## FTI-STP1 Automatic Transmission Application Bulletin/Advisory F

#### FTI-STP1 Harness Bulletin: Immobilizer Wire

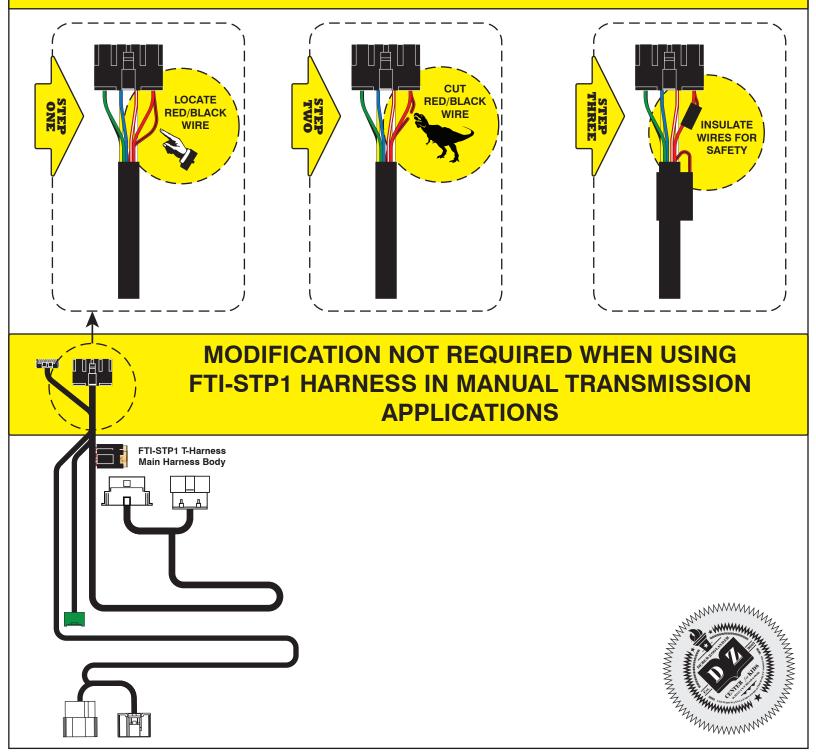
**Issue:** The FTI-STP1 T-harness has been designed to be compatible with AT (automatic transmission) & MT (manual transmission) applications, but due to a production oversight, the selection mechanism was defaulted to MT mode.

Using a harness configured for an MT application, in an AT equipped vehicle, could result in vehicle module damage, it is advised that the harness be returned to AT mode before installation in vehicles equipped with an automatic transmission.

**Correction:** Locate the **red/black** (+ Clutch) wire provided in the CN1 connector of the main harness assembly. Cut the **red/black** wire, either flush to the CN1 connector, or leaving enough wire exposed so that you can insulate and secure the ends of the wire that remain after cutting. Insulate each of the remaining ends of the **red/black** wire and secure to prevent any possibility of a short circuit.

If the red/black wire already been disconnected, no further modification is required for AT equipped vehicles.

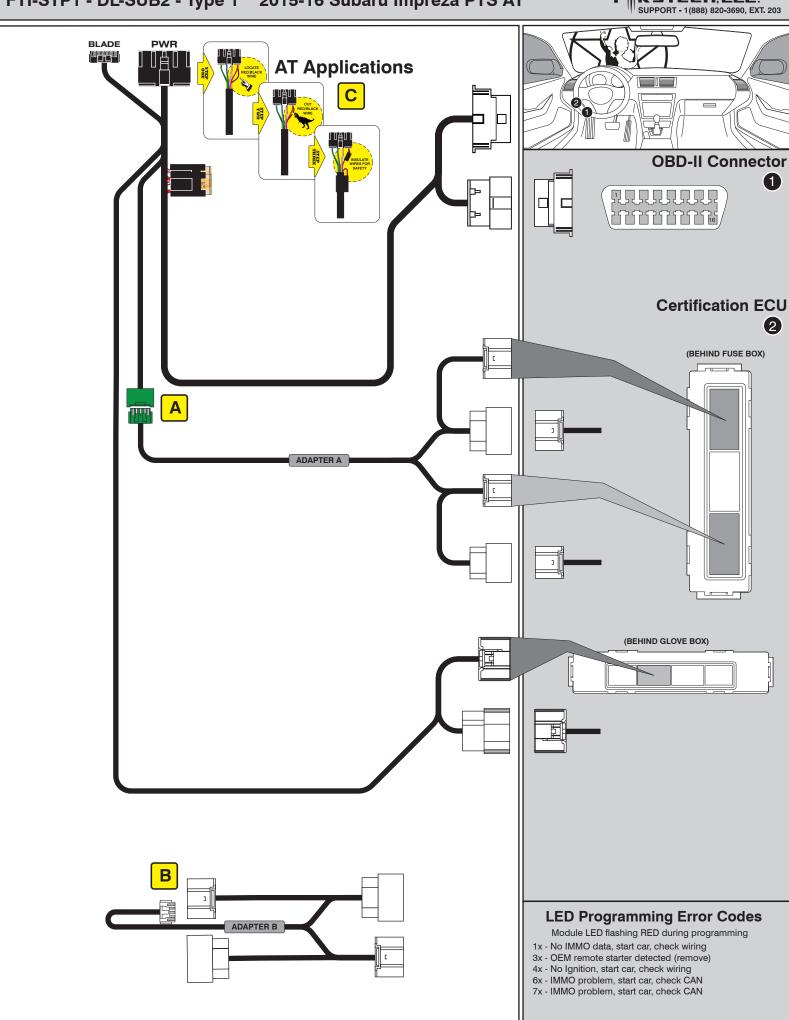
FTI-STP	1: Installation and Co	nfiguratio	n Notes							
A ADA	PTER A - <b>REQUIRED</b>					• 6	3OTH Red & Red/Wh	manual transmission. ite MUST be o current application.		
<ul> <li>B ADAPTER B - DO NOT USE</li> <li>C MODIFICATION REQUIRED FOR AUTOMATIC TRANSMISSION</li> </ul>							JUMD Parking Light II I Accessory II I Ignition (Default) Trunk II I	er Setting +Door Trigger In Default Starter I I I International Internatione International Inter		
	MMMBILIZER DATA		E-BHAKE STATUS O DOOR STATUS O TRUNK STATUS O P/N SWITCH STATUS O	VSS STATUS TACH OUTPUT SECURE TAKEOVER AUTO TAKEOVER	RAP SHUTDOWN		START ACC IGN1 IGN1	CM-900S/900AS

Fig. 2

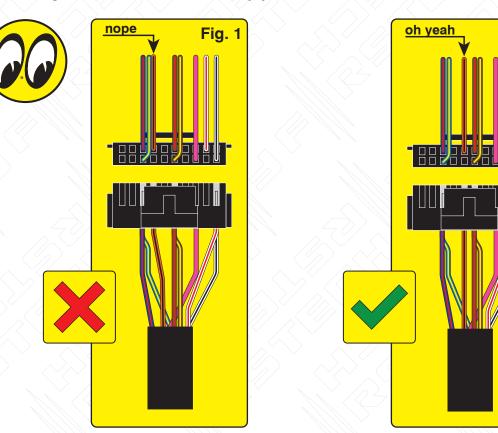
**Overview:** Production error; immobilizer wire (orange/black) in pin position #4 instead of pin position #5. Although an effort to correct the issue was made, some quantity of harnesses did get shipped before the issue was spotted. We are advising to inspect the harness BLADE connector before attempting to install the harness and program the module.

ISSUE: Module fails to program to vehicle, will not allow the vehicle to be remote started.

**Correction:** Step 1.) Locate the orange/black wire and confirm whether it is positioned as illustrated in Fig. 1 or Fig. 2. If the wire is as illustrated in Fig.1, proceed with Step 2 through 5 and complete the repair procedure outlined, if the wire is as illustrated in Fig. 2, correction is not necessary, proceed with harness installation and module programming.

- Step 2.) Using a pick, lightly depress the catch that secures the terminal in the housing then remove the wire and terminal from the housing.
- Step 3.) Using a fine tip razor or utility knfe, inseret the blade beneath the terminal catch and raise it slightly, so that it can be reused to secure the terminal when reinserted into the BLADE connector housing.
- Step 4.) Refer to Fig, 2 for correct position of the orange/black wire (next to brown/red) then reinsert the terminal, pressing lightly until the catch 'snaps' into place, securing the terminal in the connector housing.
- Step 5.) The repair is complete, proceed with installation and programming.
